RA-22-0002
January 7, 2022

Subject: Duke Energy Carolinas, LLC (Duke Energy)
Oconee Nuclear Station (ONS), Units 1, 2, and 3
Docket Numbers 50-269, 50-270, 50-287
Renewed License Numbers DPR-38, DPR-47, DPR-55
Subsequent License Renewal Application, Appendix E
Responses to Requests for Additional Information (RAI), and
Request for Confirmation of Information (RCI)

Enclosure 1:	Index of Duke Energy's Responses
Enclosure 2:	Responses to NRC Requests for Confirmation of Information
Enclosure 3:	Responses to NRC Requests for Additional Information

Figure 1. ONS project area and identified cultural resources.
Base Map: Old Pickens (1961, PR 1980) 7.5' USGS topographic quadrangle.

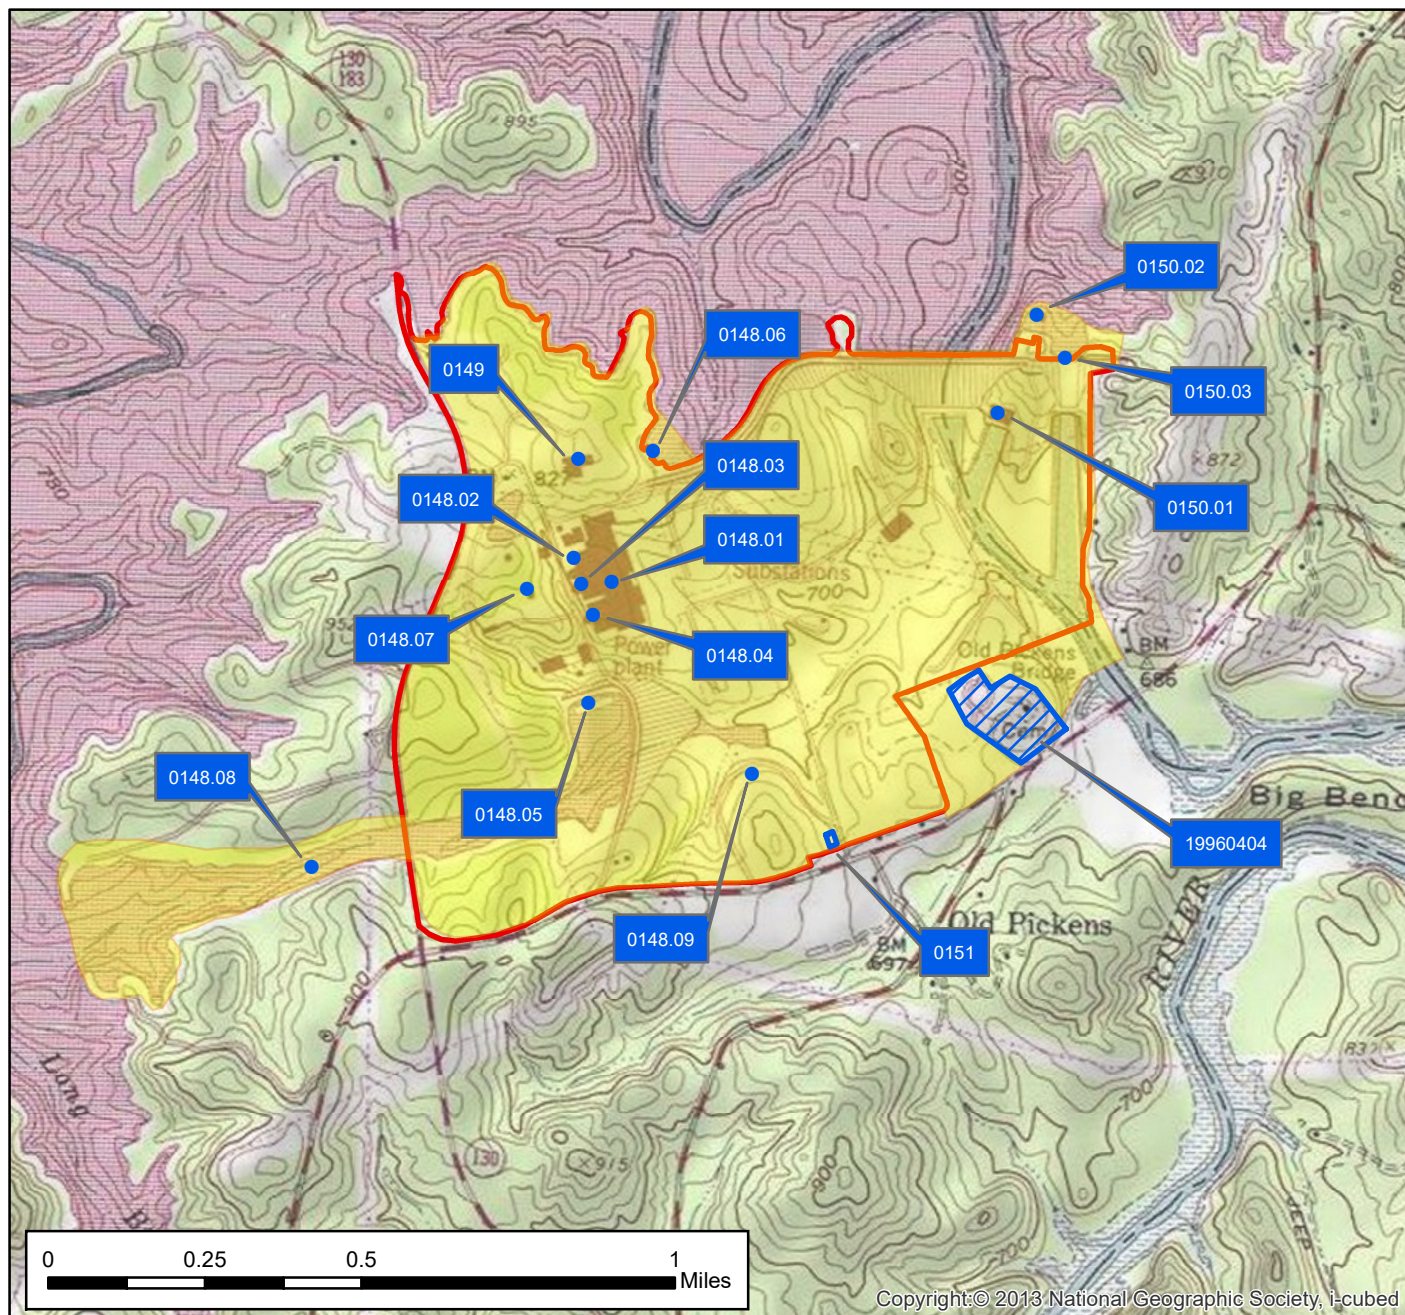
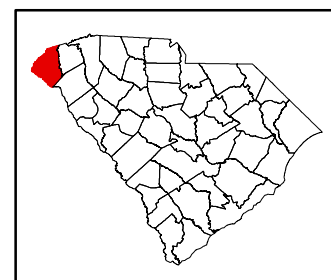
We would concur with the proposed District boundary shown in Figure 55. Figure 1 and 2's District boundary therefore needs editing to correspond to Figure 55.

p. ii, Table 1, Table of Contents, and Figures 1 and 2: add "0029/" to precede the NRIS number for Old Pickens Presbyterian Church. Use "SHPO Site Number" here and throughout the report where a site number is referenced or called "Resource No.".
